Smithsonian Institution
Revitalization of the Historic Core
Smithsonian Institution Building -
The Castle

Commission of Fine Arts
REVISED CONCEPT SUBMISSION

September 15, 2022

EYP-Loring, LLC

Figure 3.1.1.k - Perimeter security objects..

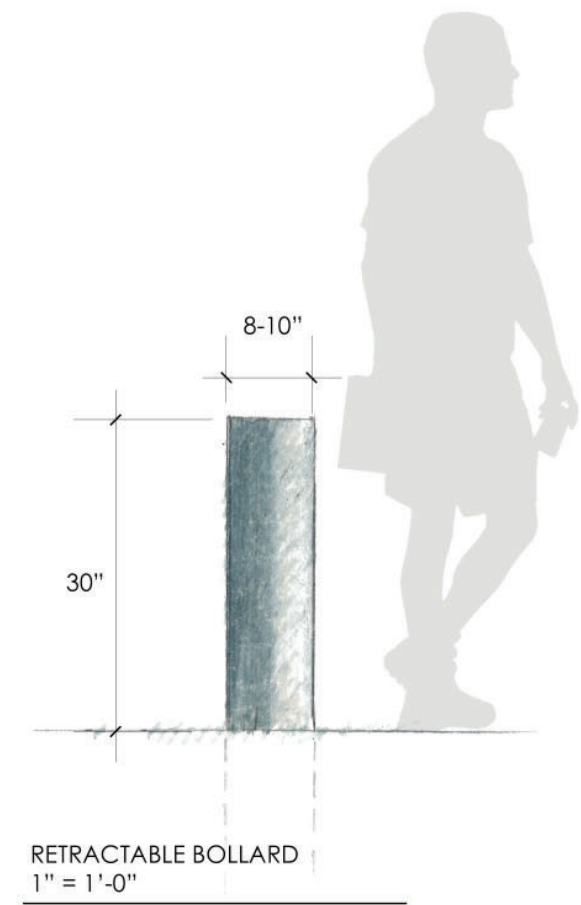
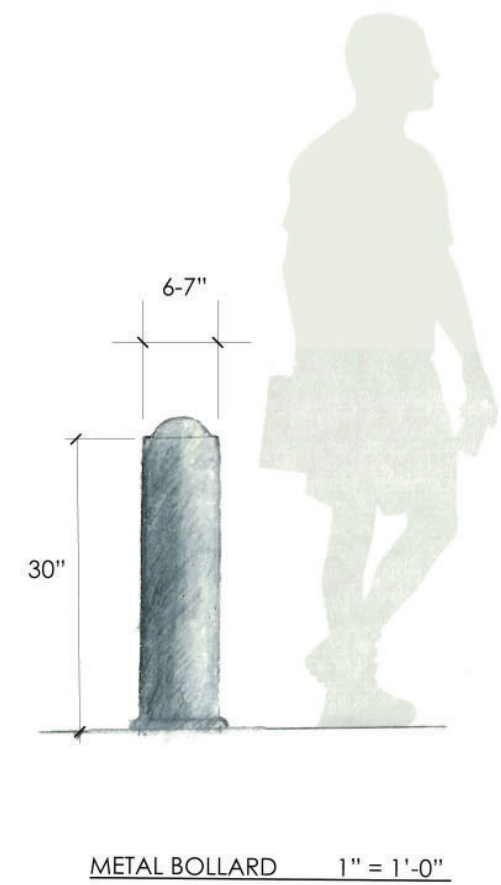
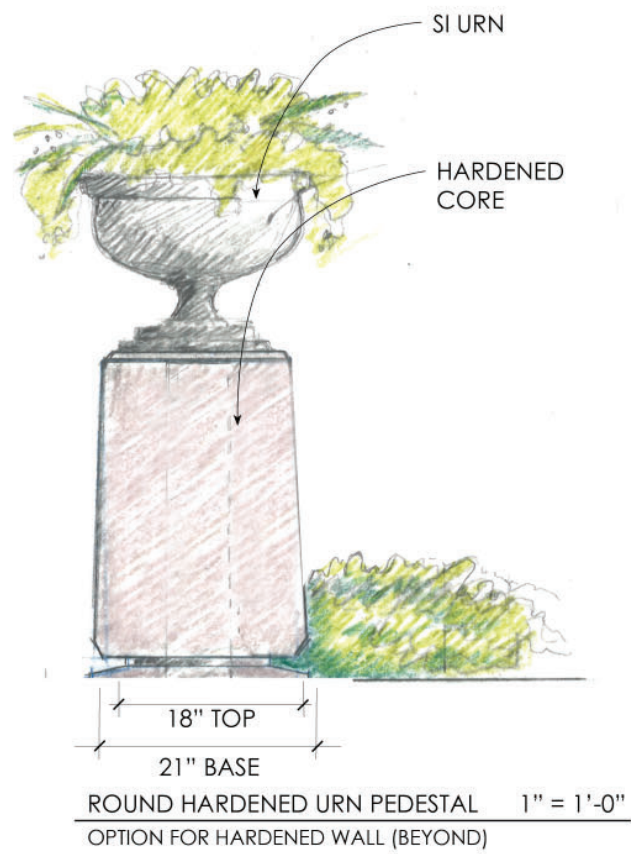
For the perimeter security system along Jefferson Drive, they endorsed the presented option with raised planter beds, but recommended using only dark-colored metal bollards within the pedestrian paths as a less obtrusive treatment that would visually recede within the landscape context.

Action- The perimeter security element designs have been further studied and are illustrated on page 16, figure 3.1.1.k.

Perimeter security objects include anti-ram bollards and hardened ornamental urn bases (Figure 3.1.1.k). Fixed bollards will be simple, metal bollards with articulated rounded tops. Retractable bollards meeting the security design criteria are required in areas where vehicular access will be needed. Both fixed and retractable bollards will be of similar color and finish for a cohesive appearance. The design team is also studying opportunities for decorative textures on the bollards at selected building locations. In two locations flanking the Castle’s north tower, stone pedestals with hardened cores will be used for perimeter security. Inspired by an urn on display to the west of the North Tower, these may be used for the exhibition of objects from the Smithsonian Horticultural Artifacts Collection. Fixed bollards and the urn base will be filled with 4,000 pound-force per square inch (psi) normal weight concrete.

Figure 3.1.1.r - Proposed Jefferson Drive perimeter security: building entrance protection with security as furniture.

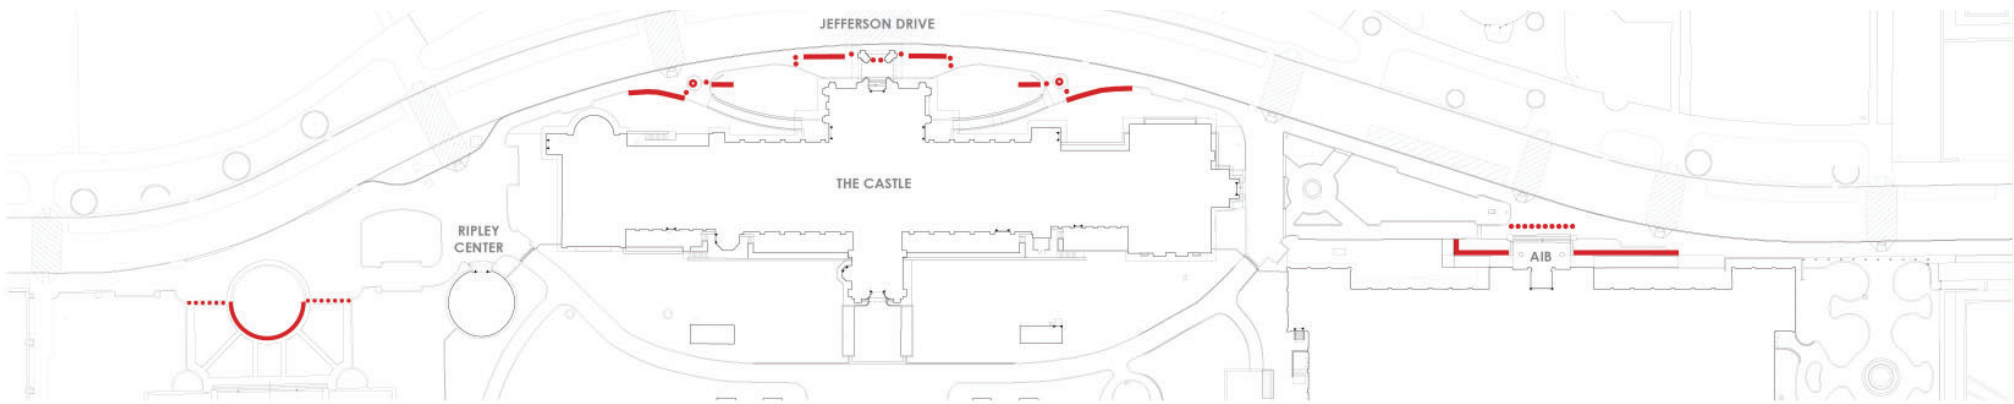
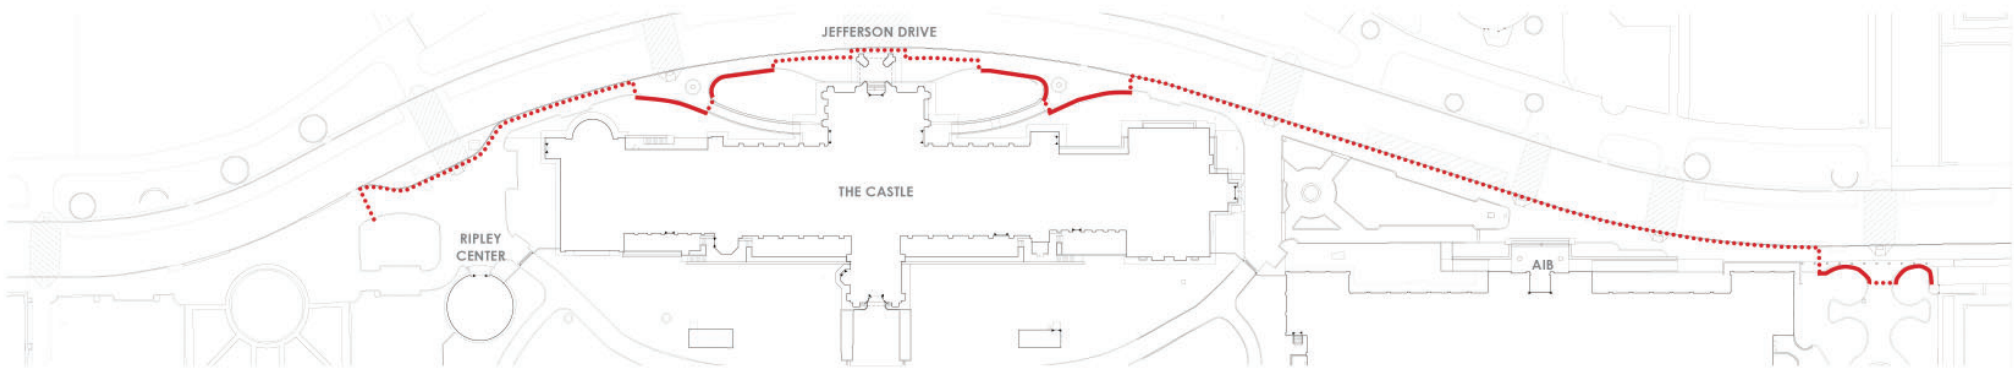
Action- Since the last meeting with the Commission and Consulting Parties the design for the perimeter security on Jefferson Drive has been revised based on a revision to the overall security requirements as established by the Smithsonian Institution Office of Protection Services (OPS). The revised requirements focus on protecting the public entrances on Jefferson Drive for the Freer Gallery, the Smithsonian Institution Building (the Castle), and the Arts and Industries Building (AIB). The revised design is illustrated in Section 3.1.1.

Along Jefferson Drive, a unified system of perimeter security interventions will protect select building entrances and queuing areas, establishing site-specific setbacks from the buildings while creating a cohesive, orderly, and integrated experience. Bollards will be used in tandem with other perimeter security elements. Hardened signs may also be employed in specific areas to decrease the number of bollards. Retractable bollards will be used strategically to permit controlled access for small utility vehicles used for maintenance. Except where space prohibits, the perimeter security interventions will be placed at the back of the sidewalk that parallels the south side of Jefferson Drive, rather than at the curb. This provides the opportunity to integrate the various components of the perimeter security system more fully with the hardscape and vegetated areas of the project area. Alternative layouts for perimeter security along Jefferson Drive in front of the Freer Gallery, the Castle, and the AIB were studied and are provided for reference at the end of this section. Detailed plans for the perimeter security interventions are presented in this report from west to east.

Figure 3.1.1.t - Proposed Jefferson Drive perimeter security: building entrance protection with security as furniture.

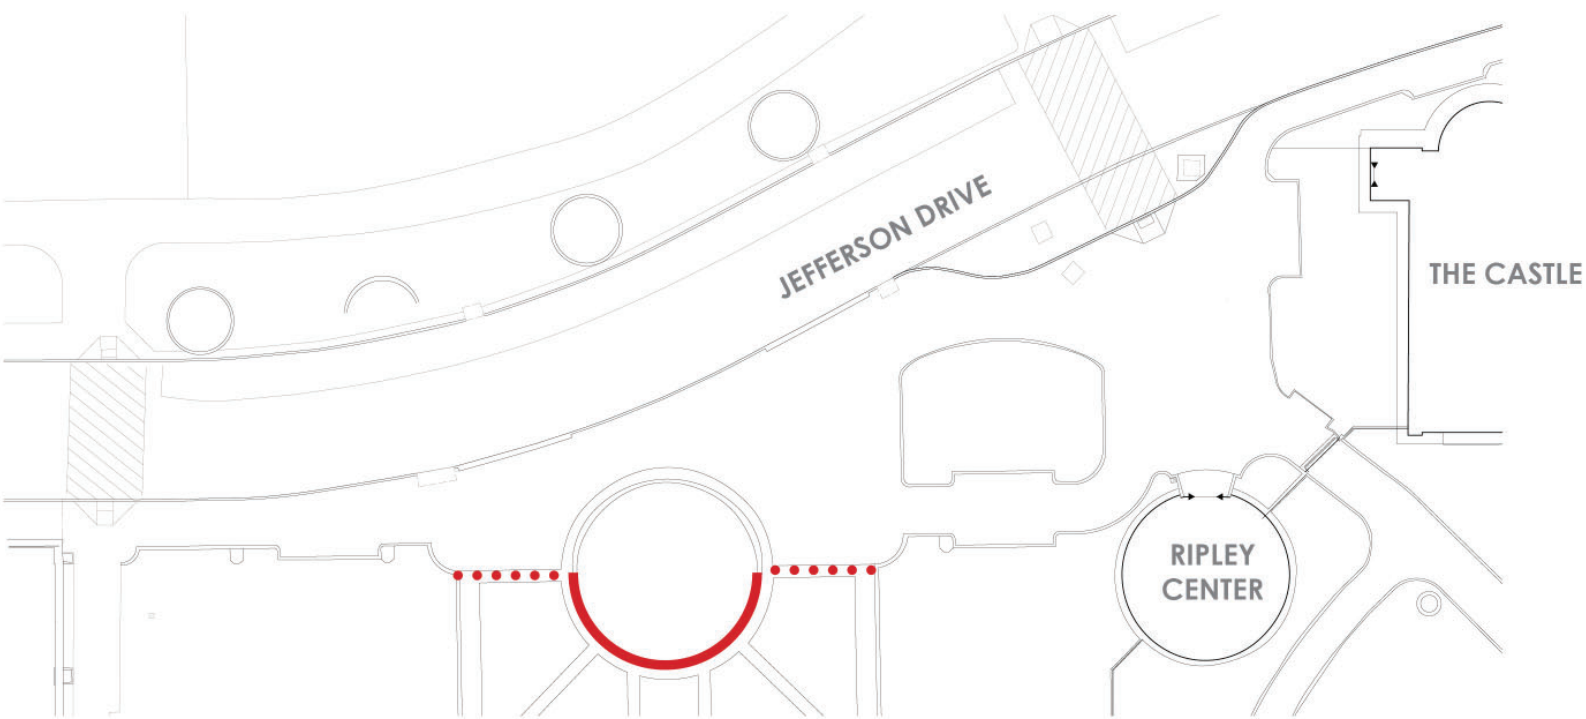
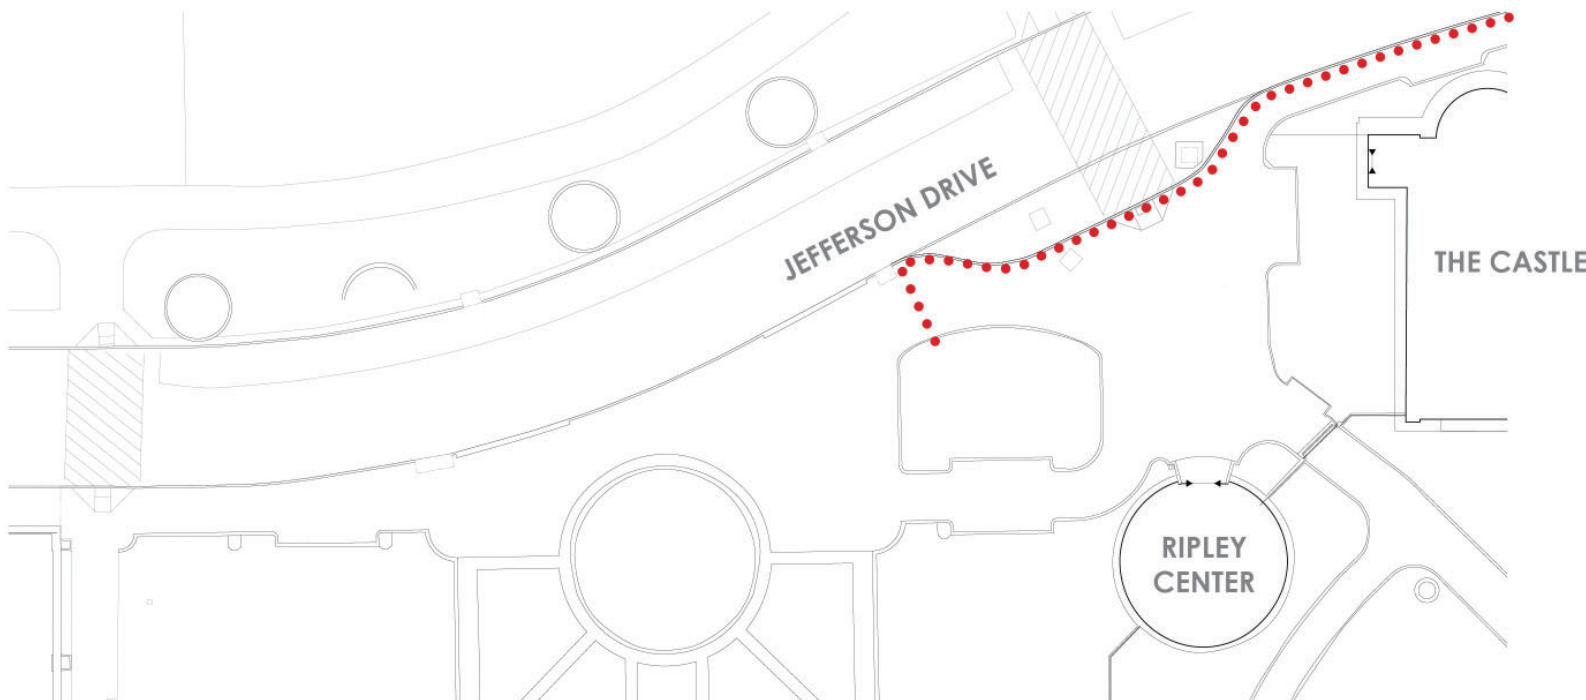
An earlier version of the perimeter security plan (Figure 3.1.1.u) proposed bollards only and did not include protection of the area west of the Castle.

As shown in Figure 3.1.1.t, the perimeter security elements for the Freer Gallery utilizes retractable bollards in the paved forecourt and hardened low stone walls with grilles along the southern half of the planted circle. The existing planted circle and pavement will be retained. Retractable bollards will accommodate controlled vehicular access to the Freer Gallery.

Figure 3.1.1.v - Proposed Jefferson Drive perimeter security: building entrance protection with security as furniture.

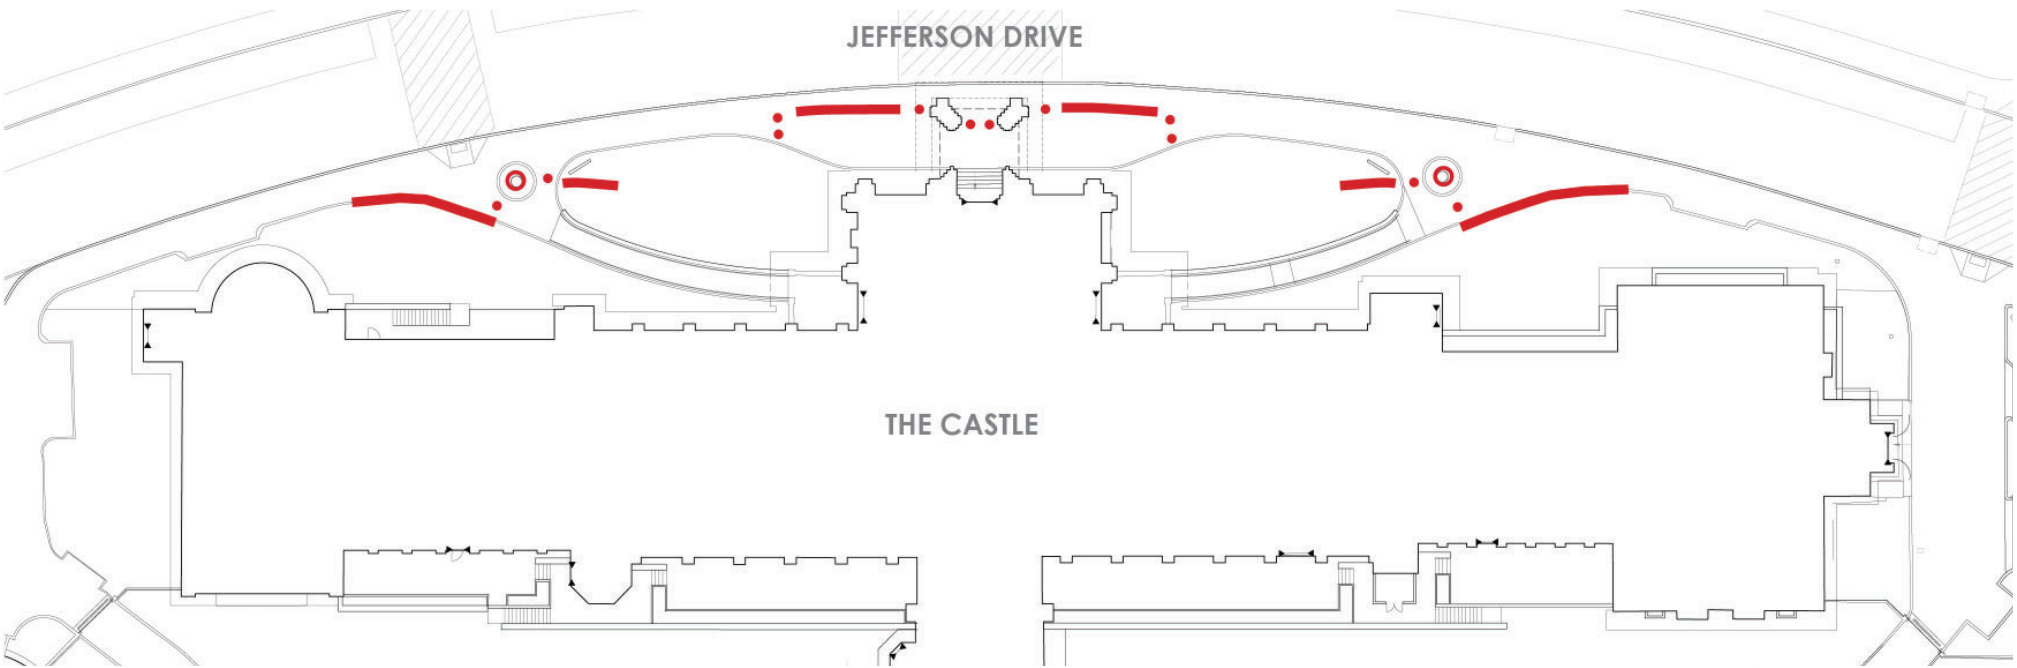
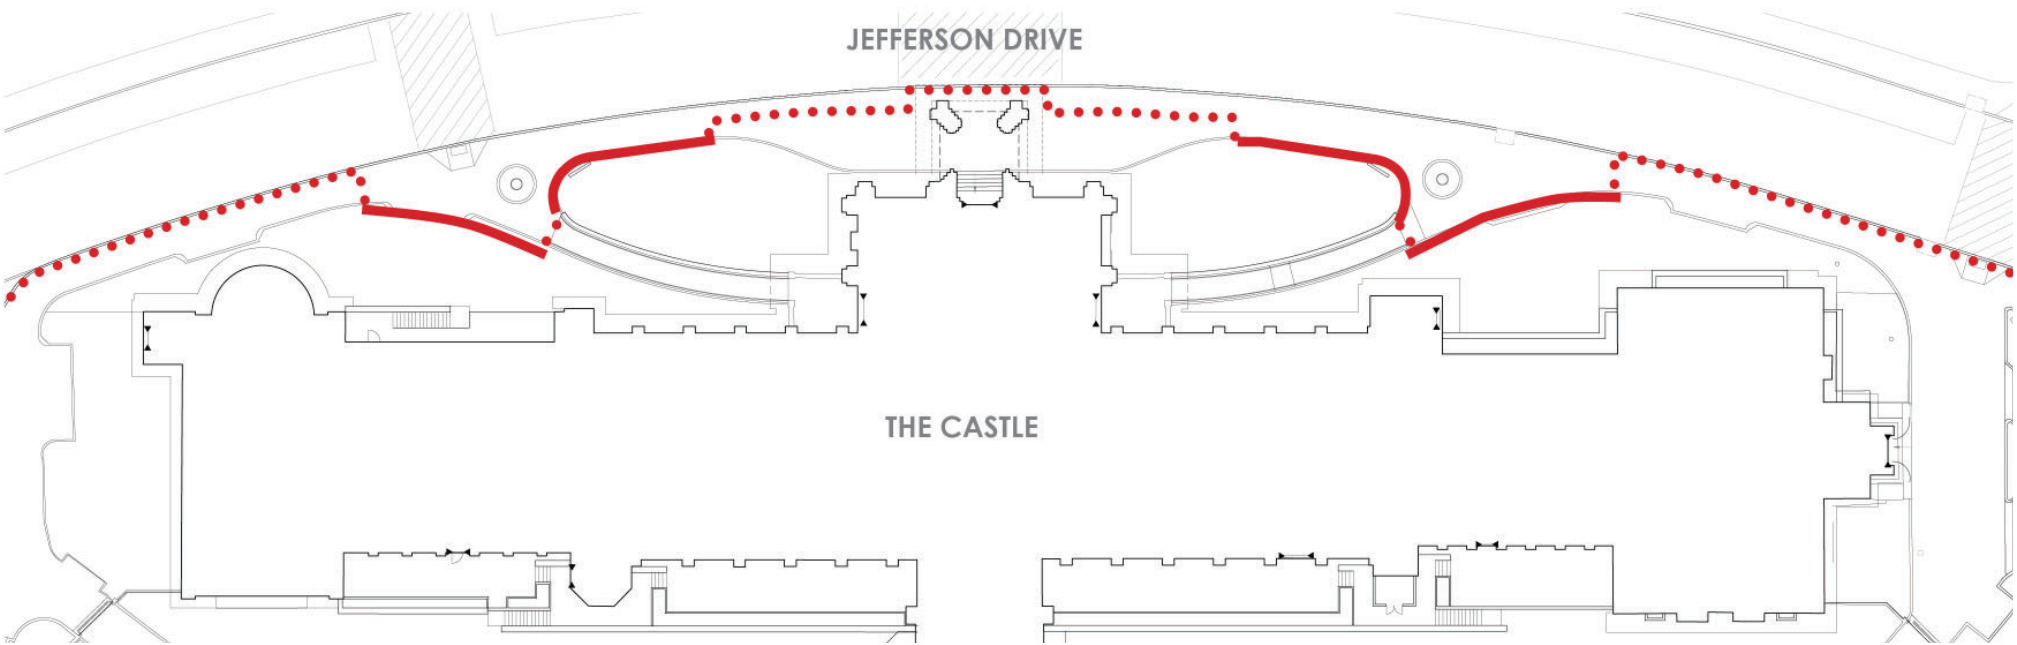
A previous version of the plan (Figure 3.1.1.w) proposed mostly steel and stone-clad bollards along the curb on the south side of Jefferson Drive and utilized raised planting areas with reinforced walls.

Figure 3.1.1.v illustrates the protection strategy developed for the section of Jefferson Drive adjacent to the Castle. Except for the area associated with the Castle’s porte-cochère where setback from Jefferson Drive is minimal, the proposed interventions are located where the Jefferson Drive sidewalk transitions to the Smithsonian’s planted areas. The interventions are a combination of low stone walls, hardened grilles, fixed and retractable bollards, hardened urn bases, and hardened seating elements.
